RESPONSE TO SUBMISSIONS

ATLASSIAN CENTRAL
8-10 LEE STREET, HAYMARKET

PREPARED FOR
VERTICAL FIRST PTY LTD
JUNE 2021

Figure 1 Rooftop Balustrade

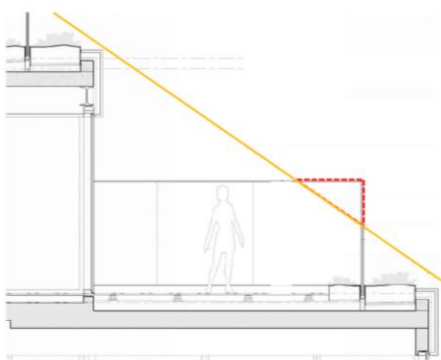
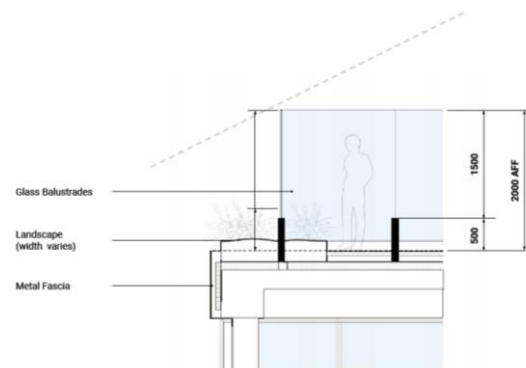
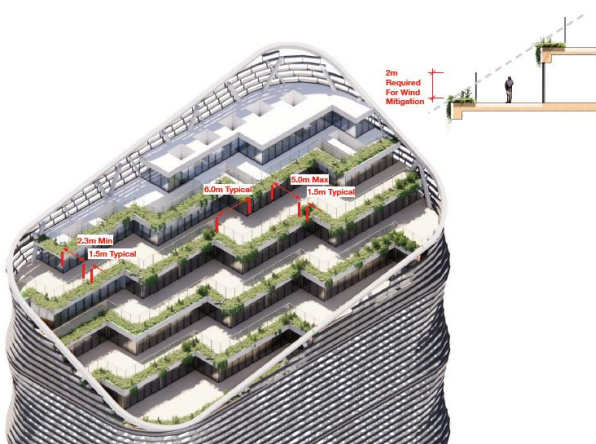
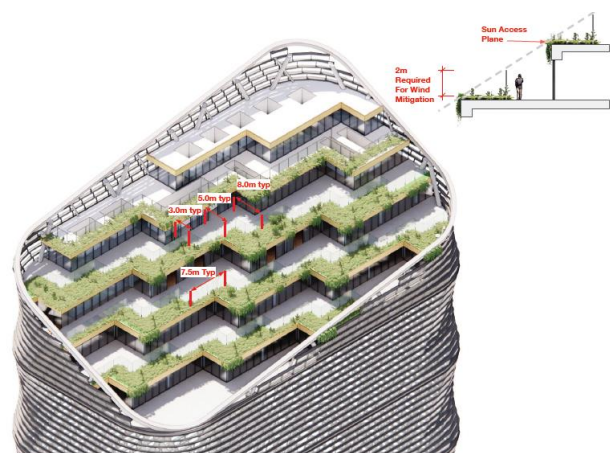
In response to submissions received from the City of Sydney and GANSW, it is proposed to set the glass balustrades back at the rooftop to ensure no overshadowing of Prince Alfred Park will occur. All balustrades are two metres tall to protect interior spaces from wind and risk of falling objects from the Crown (**Figure 1** and **Figure 2**). The proposed balustrades are setback between 1m and 3m to ensure no overshadowing occurs. Refer to the Supplementary Design Report at **Appendix B** for additional details.

Figure 6 Tower Design Optimisation - Structure

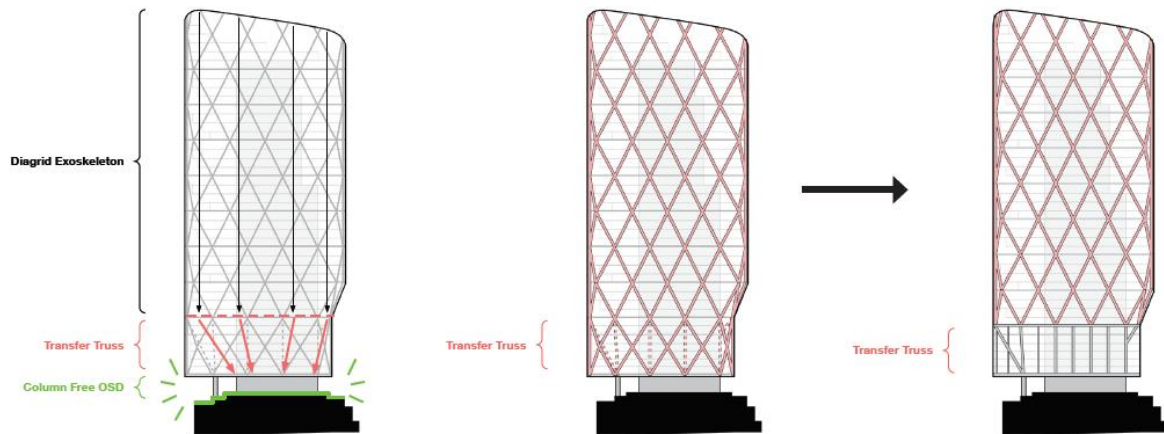
The following structural changes are proposed most of which do not alter the external appearance of the tower. The main external design change proposed relates to the YHA components of the tower which are detailed below (**Figure 6**).

- The steel exoskeleton and truss within the YHA have been replaced with 'green' concrete, a much more sustainable solution for this hard-working structure.

- The concrete structure slabs will need to come to the perimeter to tie back to concrete perimeter hangers. YHA bedrooms interior facade is eliminated. A single facade allows YHA users to have perimeter views to outdoors from all bedrooms.

Figure 7 YHA Façade Optimisation

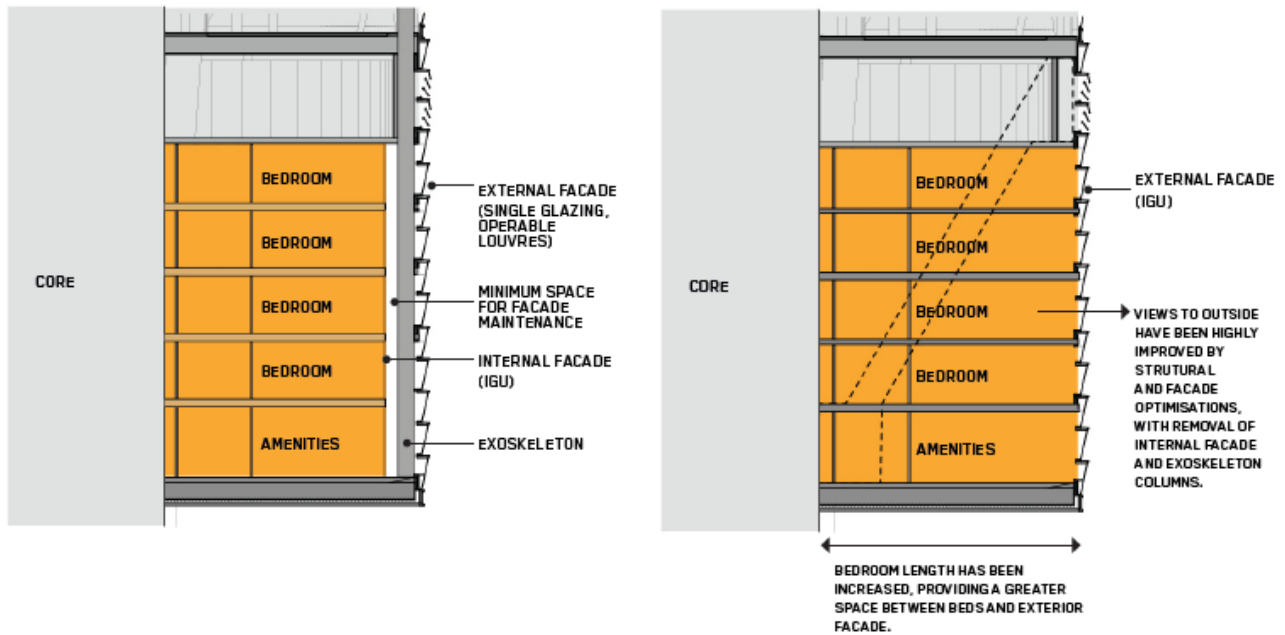
- YHA facade optimisations improved visual connection to the outside from the rooms which was partially obstructed through a second internal skin and exterior shading system. An Internal shading system is required in each room. It will provide privacy to the hostel guests.
- The extension of the floor plate to the facade has increased the bedroom length which gives an opportunity to take advantage of the space adjacent to the facade where guests can look out to the city (**Figure 7**). The hostel activities can be better perceived from outside.
- This optimisations gave also opportunity to each guest to have direct access to natural ventilation through a manually operated window located in each room.

Figure 9 Floorplate Arrangement – Lowrise Atriums

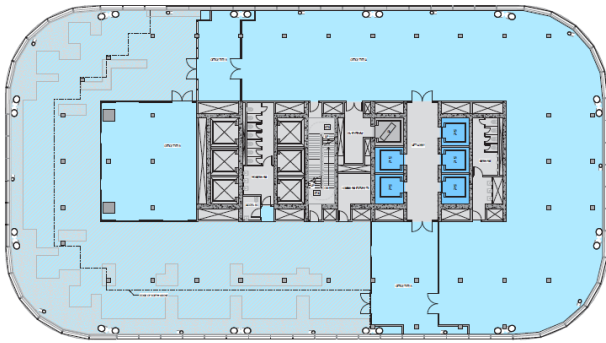
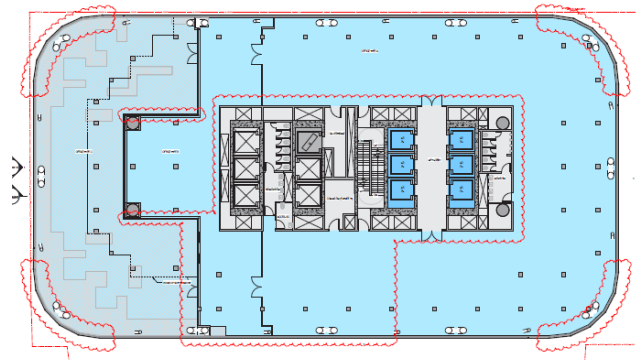
Following extensive review and to ensure the most flexible and adaptive internal planning of the future Atlassian Headquarters, the internal atrium or habitat spaces have been amended to increase the quantum of desk area. This amendment also aligns with the projected growth of the Atlassian population aligning with the future completion of the tower.

The proposed amendment results in the removal of the existing tail area of the atrium space (Refer **Figure 9** and **Figure 10**). This change was also in part responding to what is now understood to be the proposed TOGA development envelope for Block C which compromises the western outlook of this part of the building (Refer **Figure 11**).

Figure 12 Design Development – Building Corner Optimisation

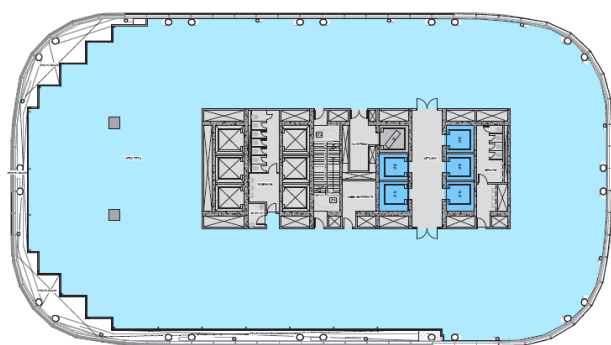
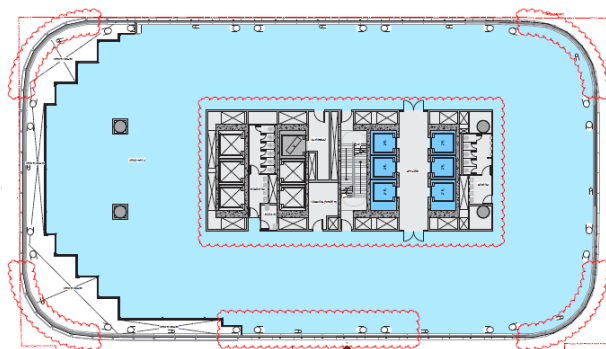
As a result of the further design development of the building design amendments have been proposed to optimise the building corners throughout the tower. This change has resulted in a corner radius change from 9m to 7m which will improve the flexibility of interior workspace arrangements in the corner areas of each floor (**Figure 12**).

Figure 13 Tower Soffit Lowering

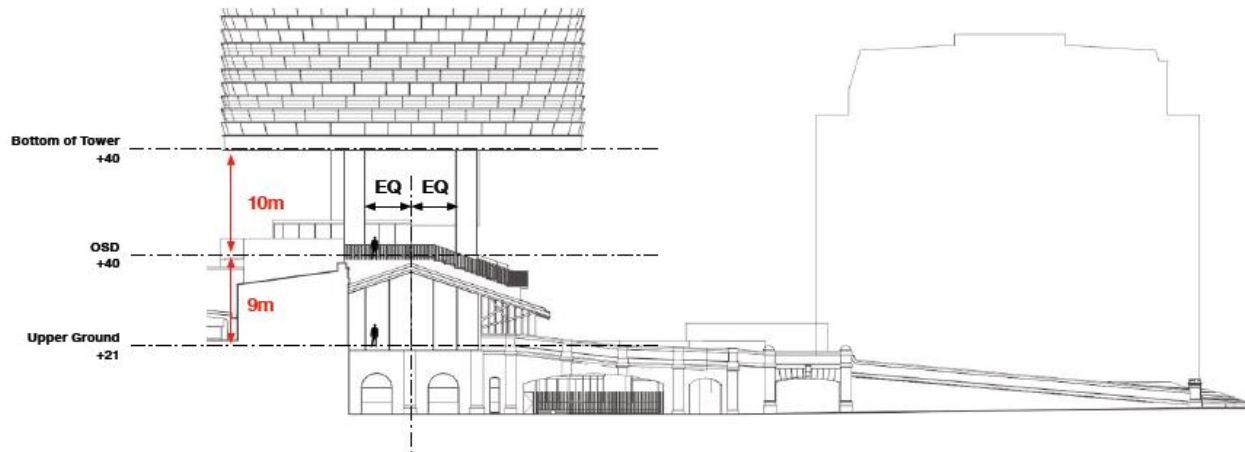
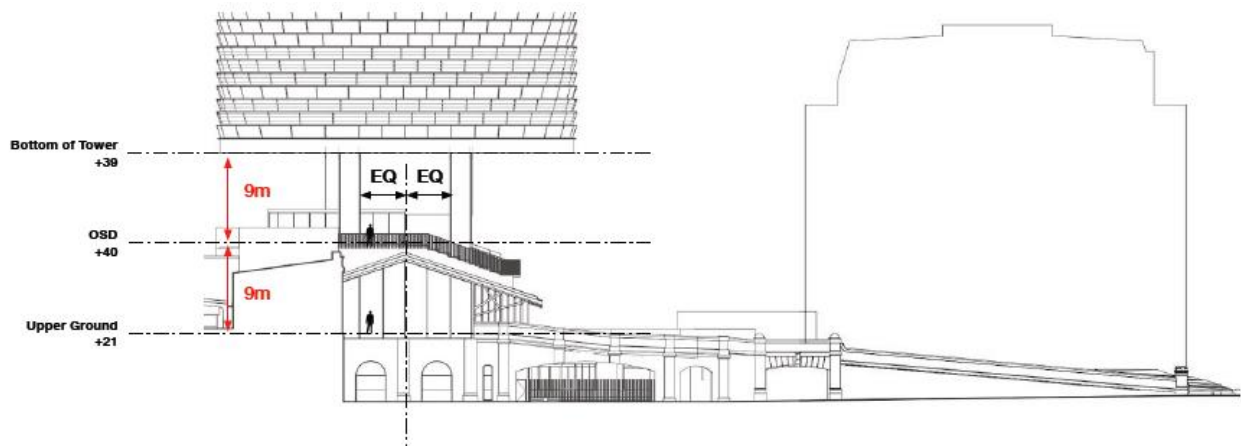
The proposed design amendment seeks to reduce the overall tower soffit height from RL 40 to RL 39 resulting in a minor non-compliance with the Draft Design Guide (Refer **Figure 13**). The negligible change to the soffit height or underside of the building envelope of 1m is required due to the need for additional spatial requirements in the floor to ceiling heights, plant and service areas to accommodate the needs of a mass timber construction building. During the initial conception of the building envelope for Block A, these spatial requirements were slightly underestimated, and have since been refined during the further detailed design of the building. The change to the soffit height from RL40 to RL39 will still support the intent of the soffit height control which is to provide separation space between the tower form and the Parcels Shed. The reduction of this separation distance of 1 metre will be hardly perceivable and will continue to enable the Parcels Shed to be viewed from close and distant viewpoints as separate building forms.

Figure 14 Design Development - Cantilevers

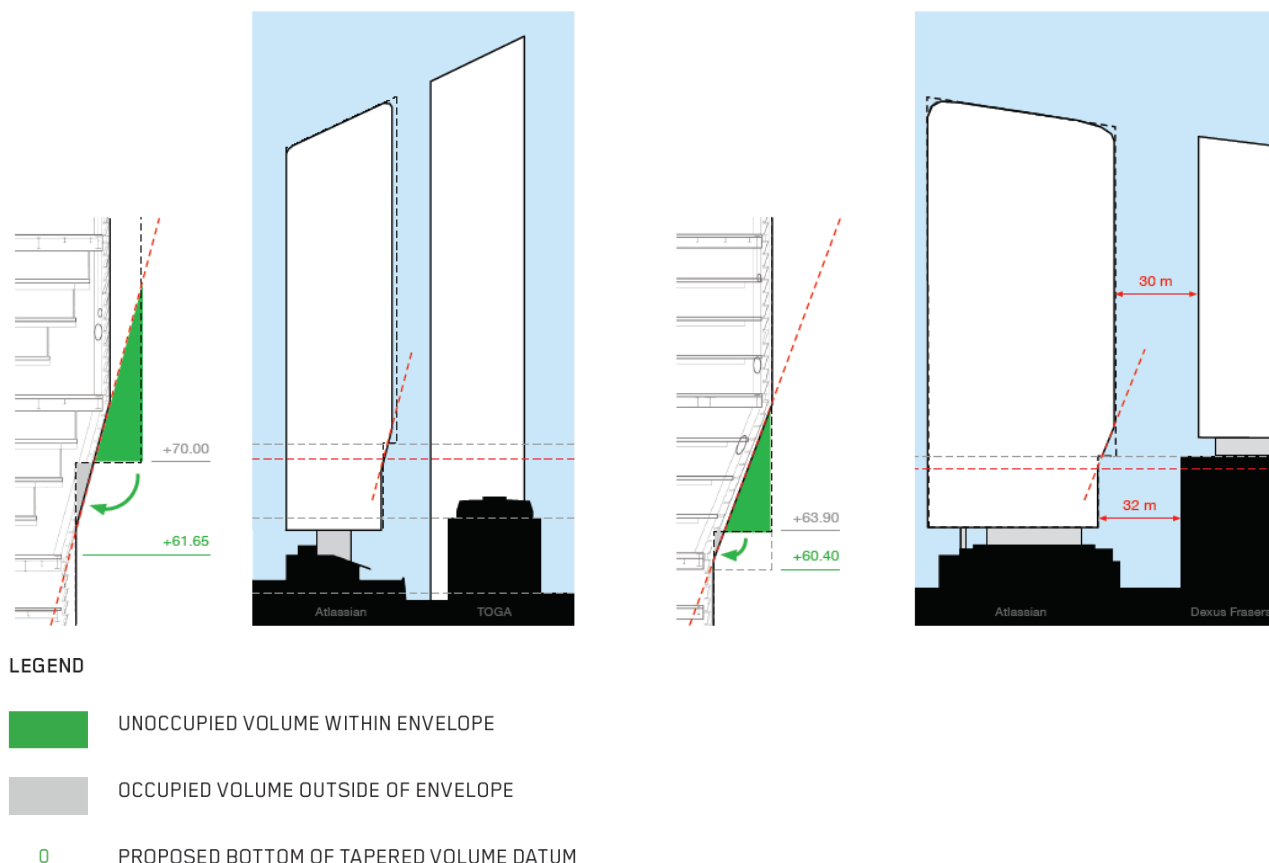
Similarly to the above, the Draft Design Guide includes provisions which limit development within specified cantilever zones on the western and southern side of the Block A envelope. The below sections summarise two minor non-compliance proposed with cantilever zones nominated within draft Design Guide (Refer **Figure 14**). The primary objective of both cantilever zones was to provide adequate space between the Block A envelope, and the adjacent Block B and Block C development sites.

The proposal seeks to deliver a tapering of the proposed massing rather than an abrupt transition and to maintain the “breathing room between the future Atlassian and TOGA developments. To achieve this geometry, while maintaining minimum office floor to floor heights in the tower, a piece of the cantilever volume is “relocated” to the narrower portion of the tower below, as shown with a green arrow in the above figure. The result is a smoother and more generous transition to the cantilevers, which provides a much improved quality of urban design for the Precinct. It is noted that the quantum of unused volume far exceeds the volume that is proposed to be relocated lower.

Figure 15 Proposed Signage Zones

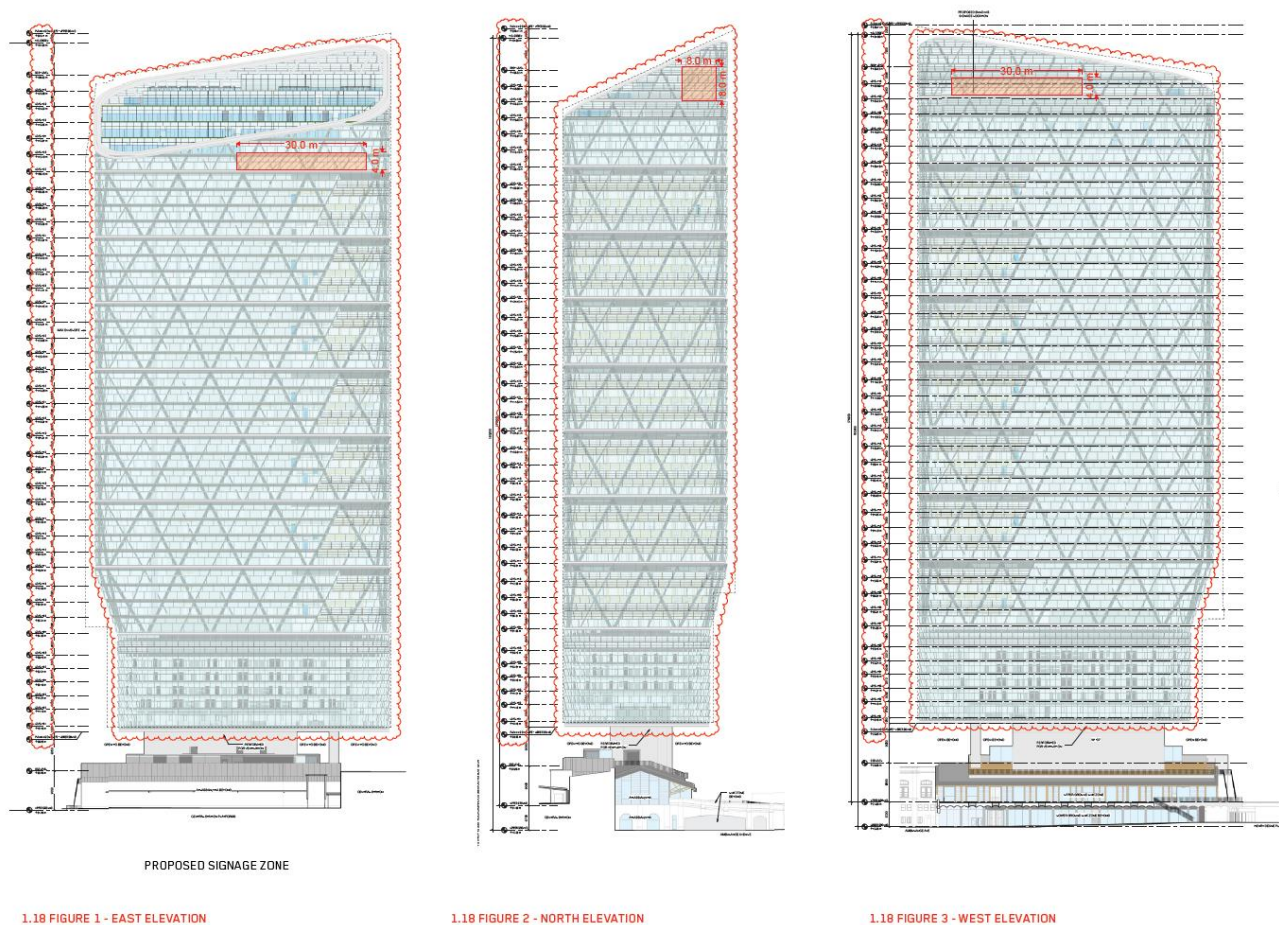
Figure 15 identifies the three top of building signage zones proposed on the eastern, northern and western elevations.

The proposed signage zones have been located to respond to the external and internal architecture of the development. The future detailed signage is proposed to be illuminated and will be subject of separate approval as part of a detailed signage strategy.
